Request of Class II Permissive Change

Company name: Anker Innovations Limited

FCC ID: 2AOKB-A2567

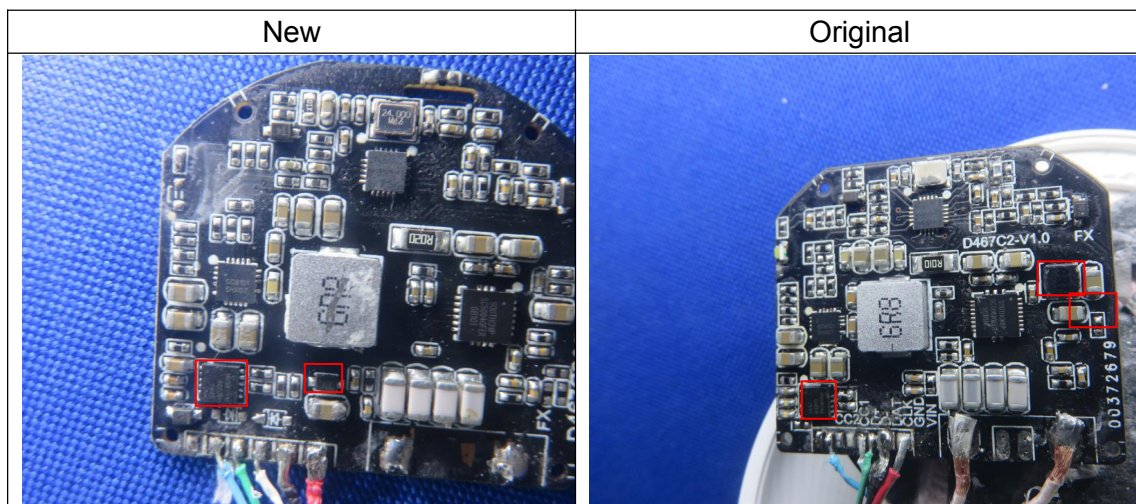
1. Delete the L2 inductor of the V3 PCB board.
2. Delete the C29 capacitor of the V3 PCB board.
3. Increase the C20A capacitor on the V3 PCB board.
4. Changing the IC chip "SC500" to "SC5004".

The changes are not related with the other RF parameters, only "SPURIOUS EMISSIONS" of A2567 were retested, other data were referred to the original report.
